## APPENDIX K2: STORMWATER RFI RESPONSE LETTER

**RE: COUNTRY CLUB ESTATE**

**DRAFT AMENDMENT 4/2020 - REQUEST FOR FURTHER INFORMATION**

**CIVIL ENGINEERING ITEMS**

Figure 1 - Predicted Future Flow Rates - LPD 7

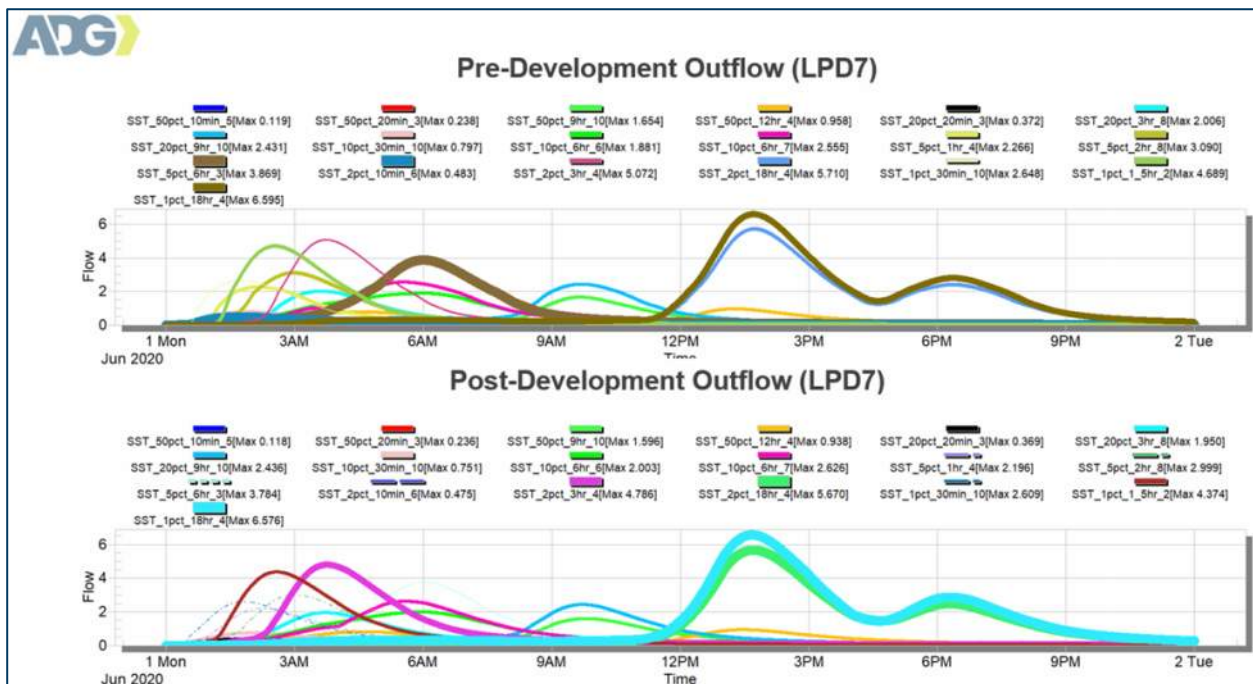
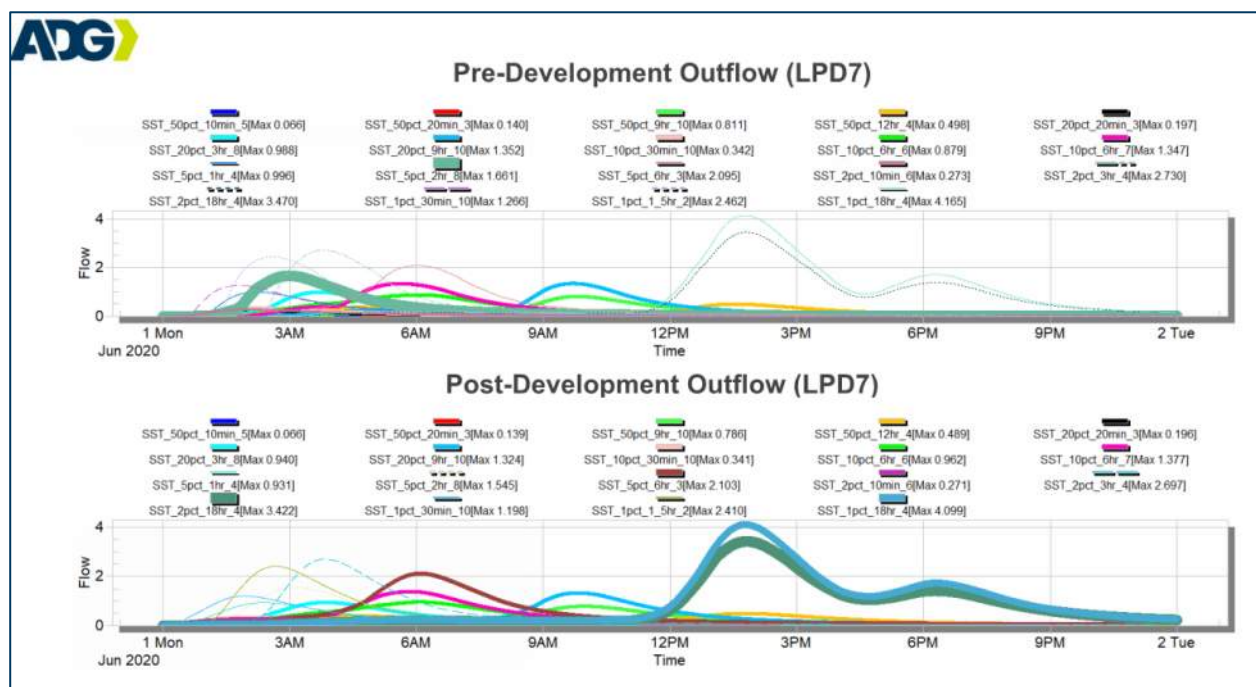
2 (e) (i) Part 2	Has the climate change scenario been factored into the stormwater modelling?	The stormwater modelling in ADG's stormwater management plan considered the current climate and does not currently consider any predicted changes to the climate over time. Refer below point for further comment.

2 (e) (i) Part 3	If not, this needs to be discussed and justified, or alternatively, the climate scenario is shown and associated mitigation described.	<p>The stormwater model has been re-run with rainfall intensities increased by 39.84% in order to represent predicted climate change impacts as listed in the Climate Futures for Tasmania. The overall site stormwater mitigation philosophy is unchanged, however, if the development is to mitigate the future flow rates to the pre-development case flows at year 2100, some additional detention would be required in the eastern basin due to the greater volume of water. The design of the outlets from the west lake is unchanged from the previous model. It should be noted that the increase in rainfall was found to result in a smaller increase in site discharge than that predicted in the flood model advice provided by Council's Hydrologist (6.6m<sup>3</sup>/s vs 10.4m<sup>3</sup>/s at LPD 7). We have not assessed the capacity of Councils drainage network for predicted increases in flow rates.</p> <p>The below results show the predicted future flows across/under Country Club Avenue (LPD7 in our report) and coincide with a max water level in the east lake of 170.89m AHD, which will require filling around the existing dam outlet (already necessary without rainfall intensity increase) and some additional localised filling to a depth of approx. 300mm over a length of 30-35m centered approximately at: 41°28'56.8"S 147°06'54.9"E. This filling would be required to provide a shallow bund and prevent the existing lake overflowing through this area in the event of very intense rainfall. There is a modelled increase of about 90mm to the water level in east lake between the pre and post development cases.</p>

**SECTION C-C**  
1:200

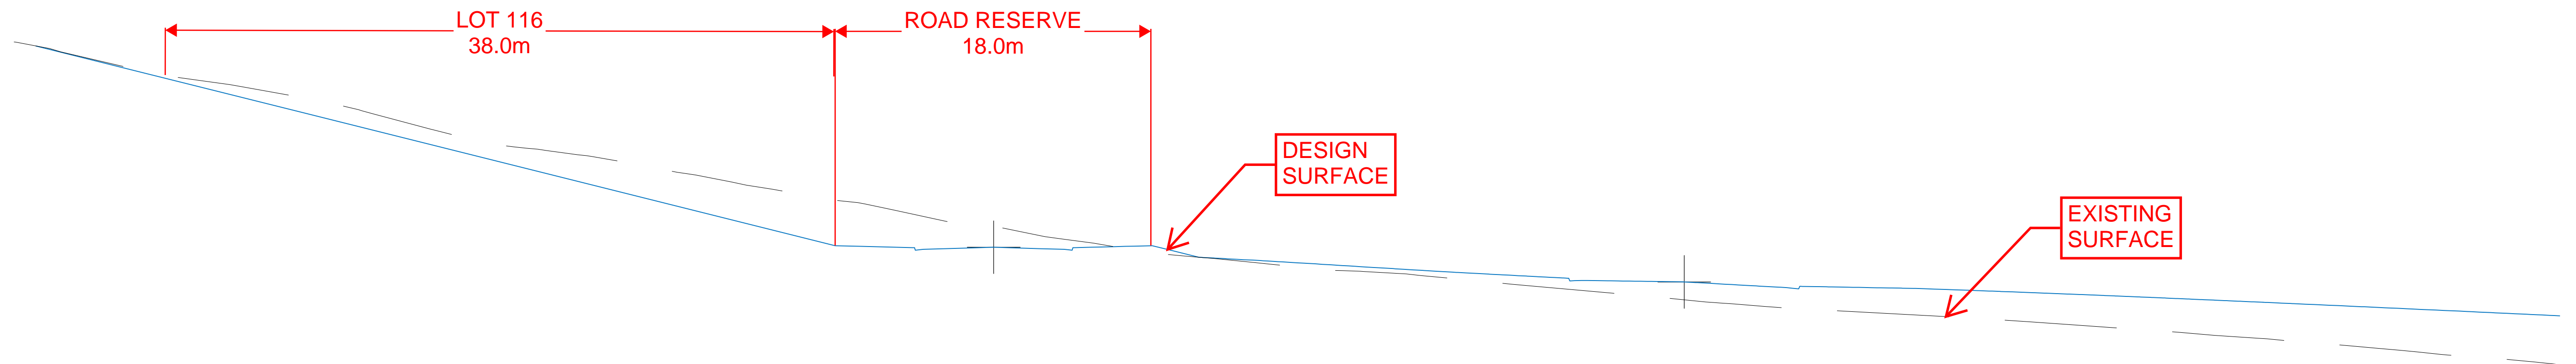
2 (e) (ii)	<p>Subdivision Design: Post construction sections are required through:</p> <ul style="list-style-type: none"> <li>• Lots 303, 314 and road;</li> <li>• Lots 274, 293 and road;</li> <li>• Lot 116 and road.</li> </ul>	Please refer to the attached ADG Cross Sections.
